**ST. LUCIE EXAM
50-335, 389/2001-301**

LICENSEE POST-EXAM COMMENTS

Re: St. Lucie Units 1 and 2
Docket Nos. 50-335 and 50-389
Operator License Training Program
May 21, 2001 RO/SRO Exam Comments

FIGURE 1

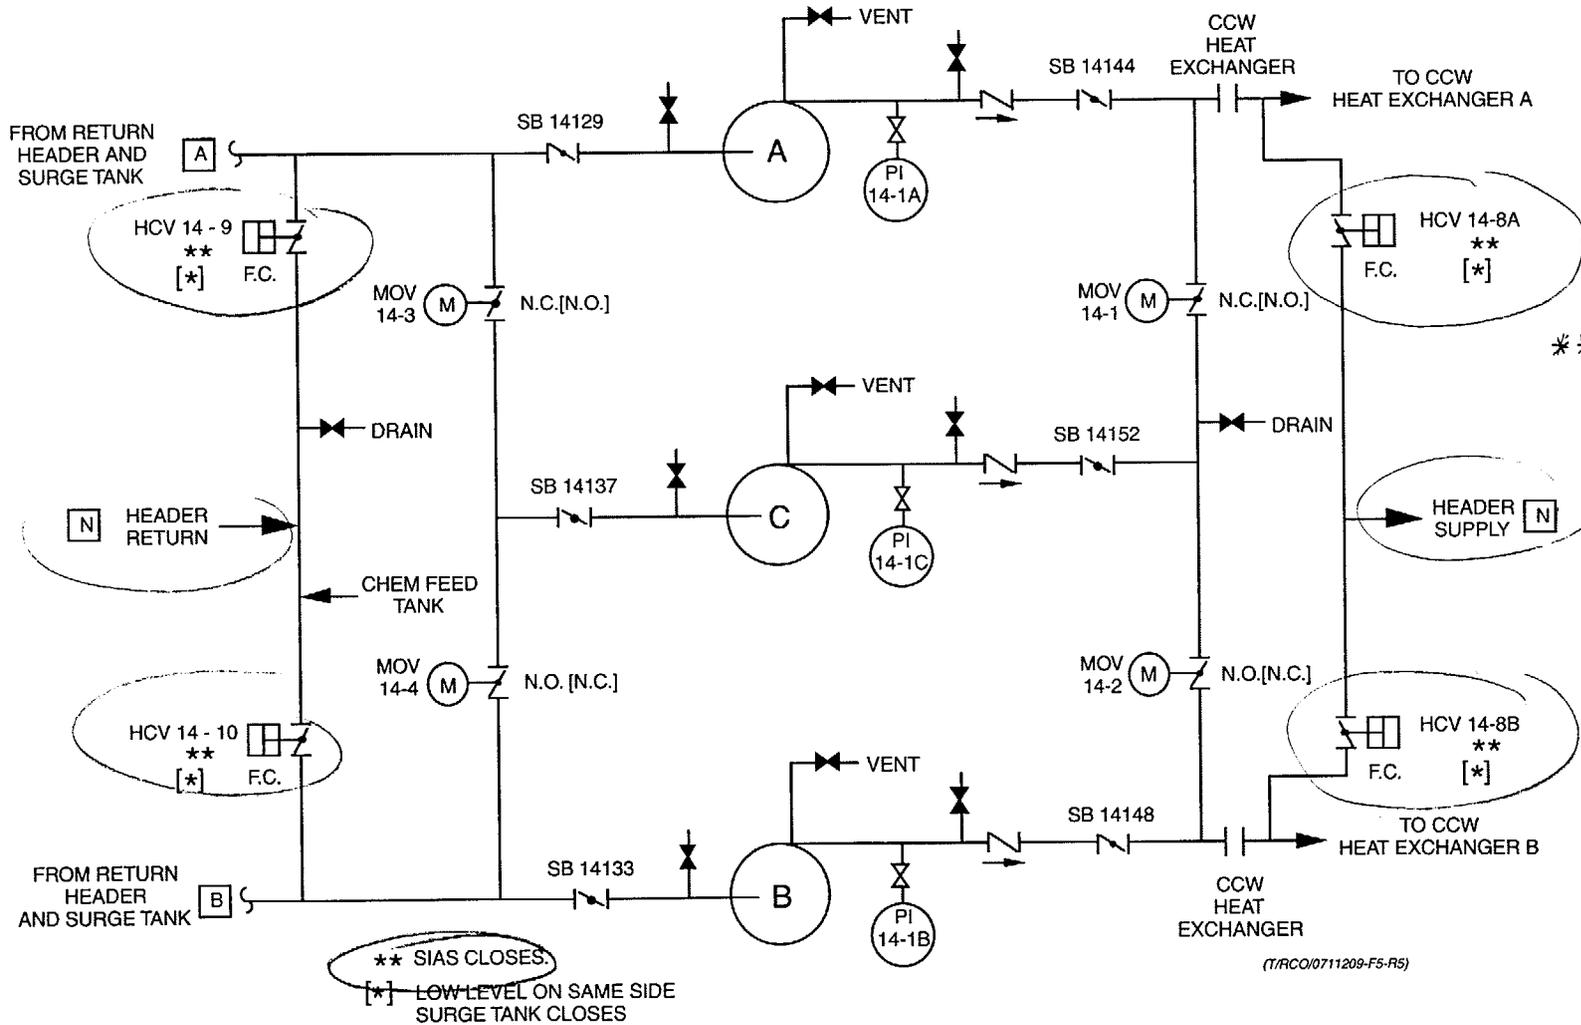
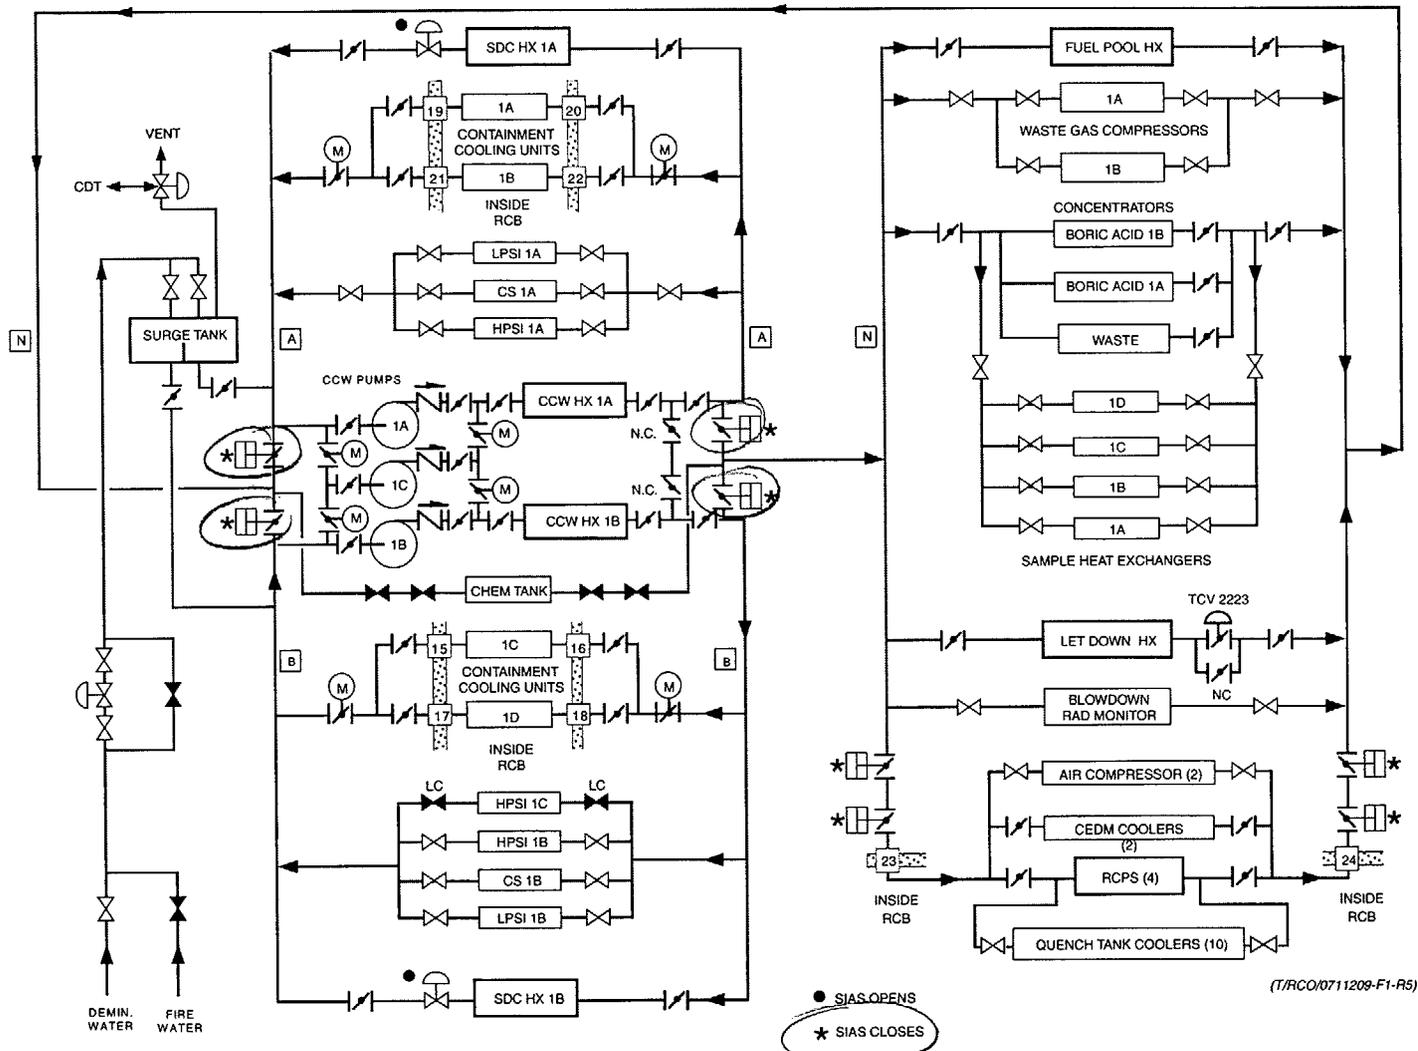
This question asks which CCW header(s) will the 1A CCW pump be supplying after a LOOP followed by a LOCA. The key indicates that "C" is correct because it is assumed that SIAS has occurred isolating the "N" header therefore separating the "A" header from the "B" header. Some candidates selected distractor "D" because the stem did not provide enough information to determine that SIAS had actuated.

Recommendation: Accept C and D as correct responses.

FIGURE 9
RWT LEVEL VS. CONTAINMENT SUMP LEVEL

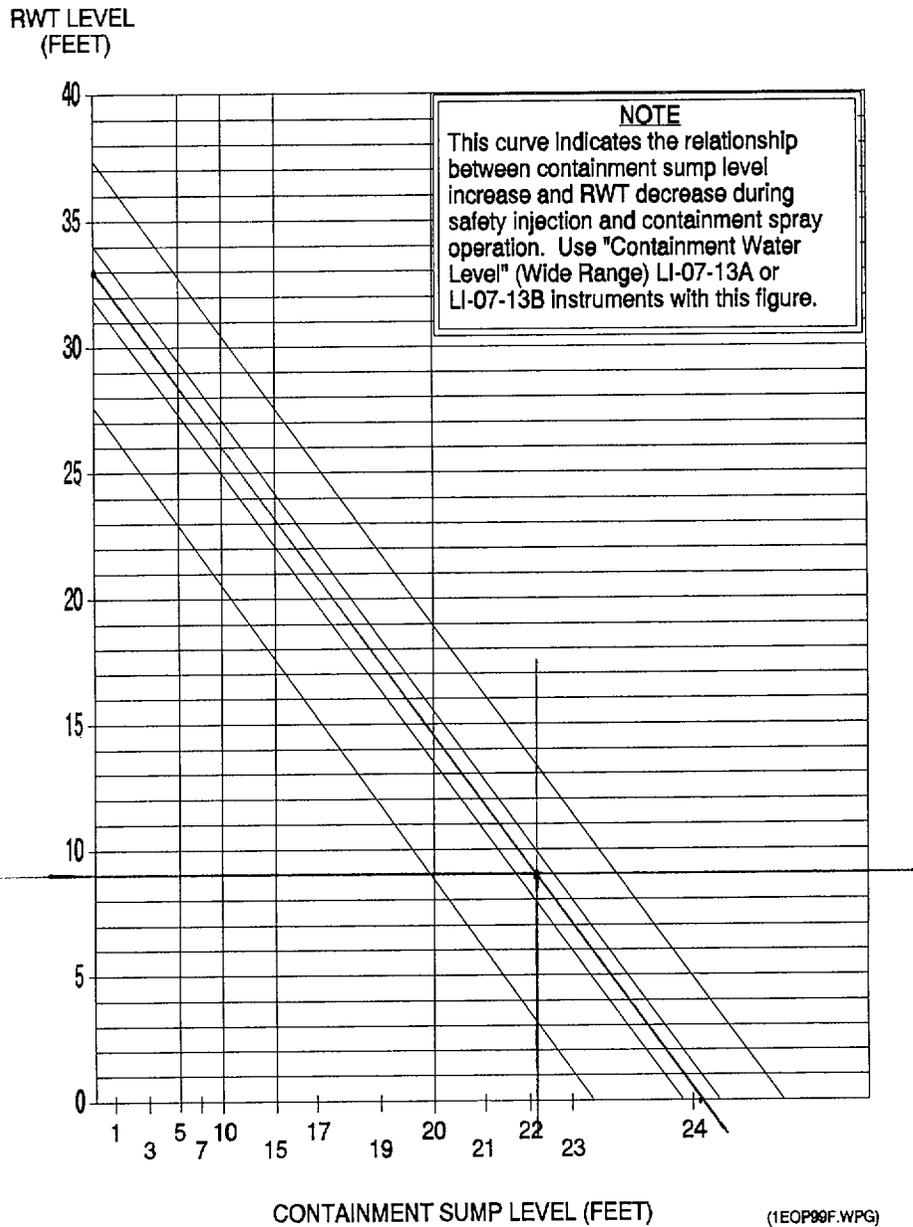
This question asks the student to determine if the proper RWT inventory has been transferred to the containment sump.

Using the attached reference drawing (Figure 9) a diagonal line is drawn representing 33 feet between the two solid lines for 32 feet and 34 feet. Follow the 9 foot RWT level line straight across to where it intersects the initial 33 foot line. Drawing a straight line down to the x-axis from this point results in an expected CNTMT sump level of slightly greater than 22 feet (approx. 22.2 feet).

Since the actual sump level is 22 feet, it was assumed by some of the candidates that some sump inventory has been lost outside CNTMT. Conversely, depending on how precise the data is evaluated on Figure 9, it is evident how some students determined that all water in the RWT had been transferred to the CNTMT sump.

Recommendation: Accept B and D as correct answers.

FIGURE 7
TOTAL LOSS OF MAIN FEEDWATER FLOW
RCS TEMPERATURES vs TIME

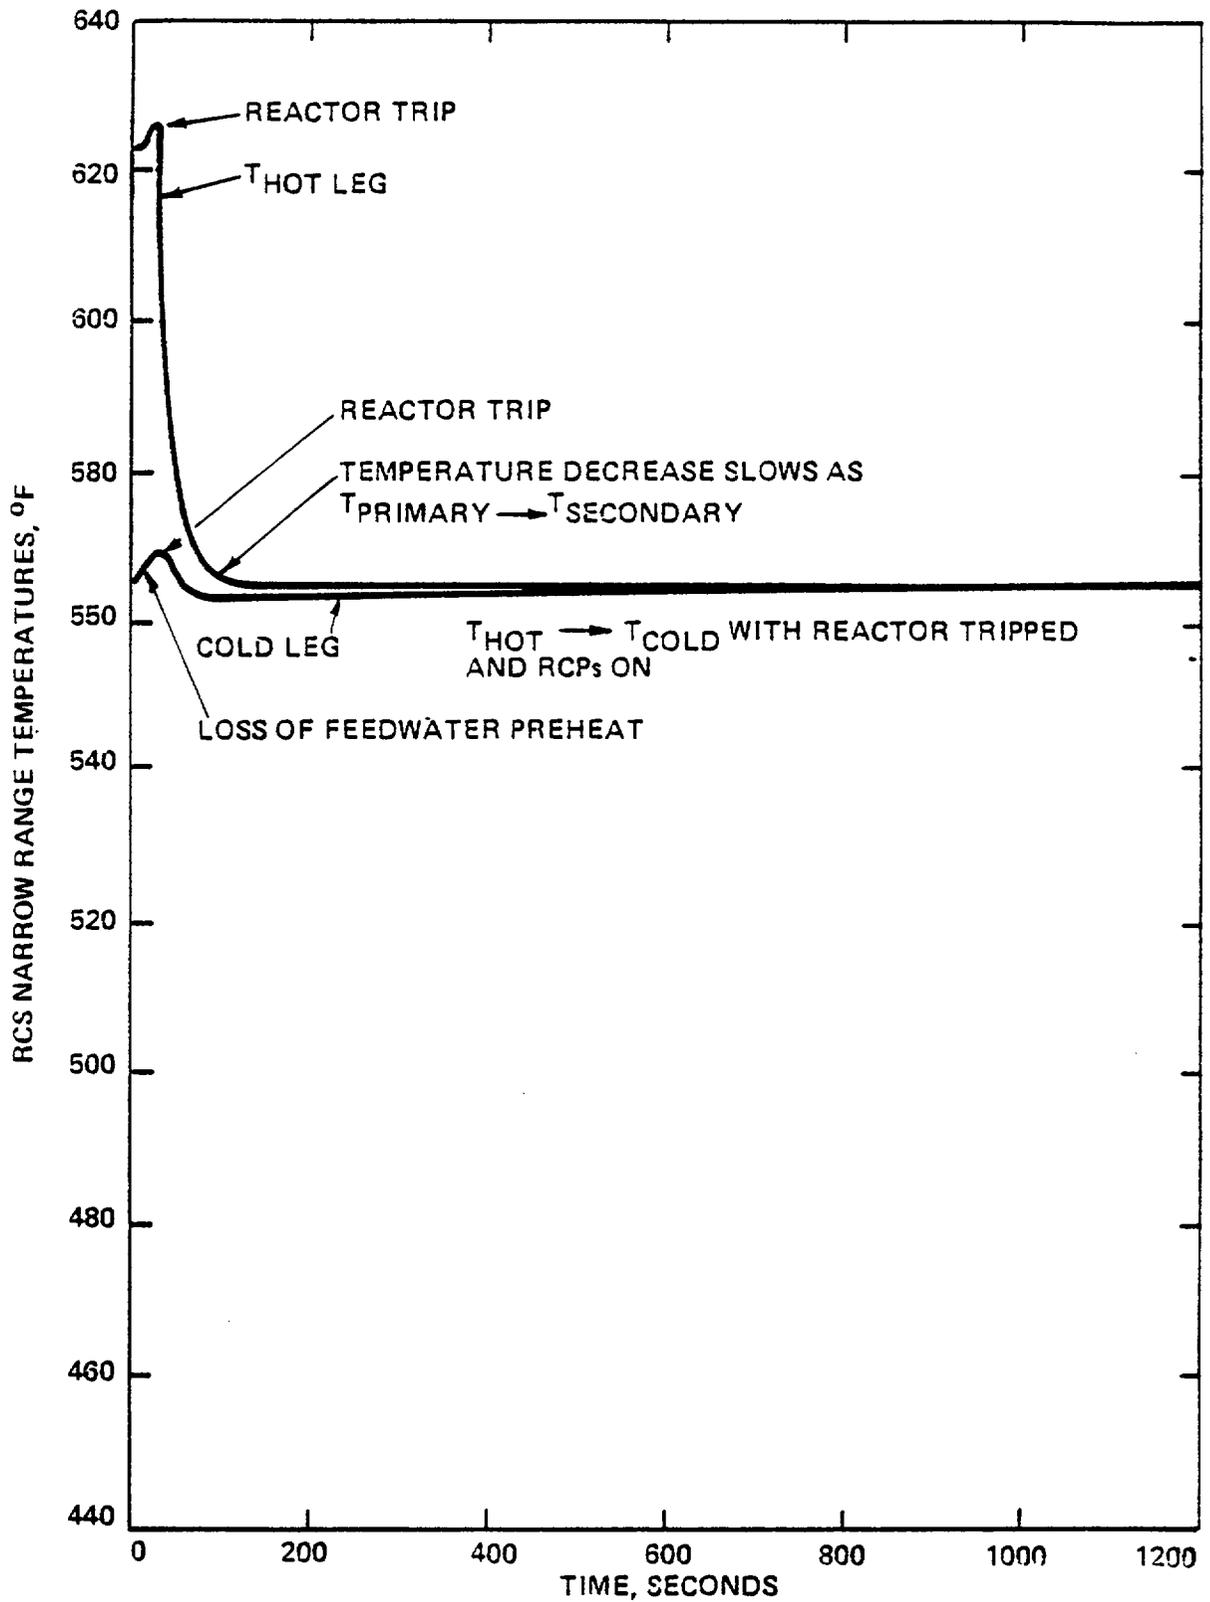
This question describes a Loss of Feedwater ATWS event. The initial plant response to this transient will be the same as the non-ATWS event before the reactor trip. The key issue is that the change in reactivity is due to an event external to the reactor. As such, the physical change to the moderator is the first event which can change reactivity.

RCS hot leg temperature is initially constant but RCS cold leg temperature increases. The initial reactivity change will be determined by MTC. There are two cases, positive and negative. (Refer to the attached documentation for additional information on the expected RCS temperature response: a. Combustion Engineering Emergency Procedure Training Materials, "Loss of Feedwater Lesson, pages 2-2, 2-3, and Figure 7", CEOG, b. Post-TMI Reactor Operation Training Materials – Lesson Plans for Transients and Accidents {CEN-128}, pages 3-1, slide 15, CEOG)

Recommendation: Accept B and D as correct responses.
